# **87C196KQ SPECIFICATION UPDATE**

Release Date: January, 1997

Order Number: 272837-002

Figure 1. 16-bit System with EPROM

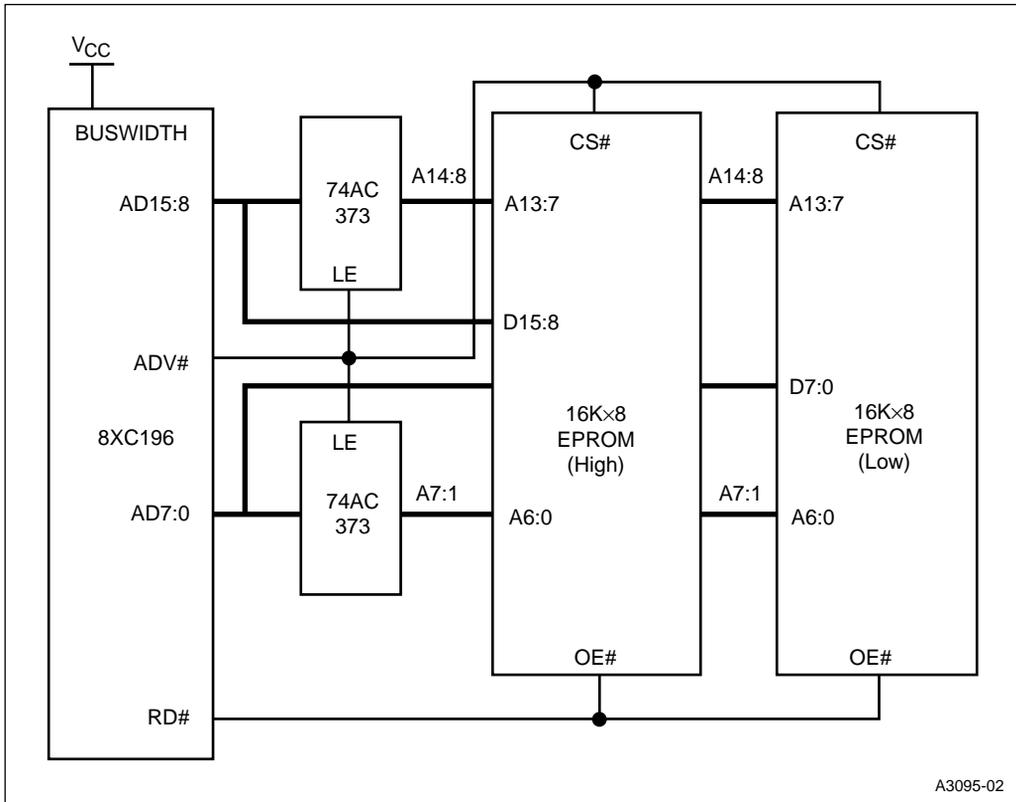
- 001.**        *High address inputs to the low EPROM should be A14:8 in Figure 15-18.*

**ITEM:** The next revision of the user's manual will include the following corrected graphic.
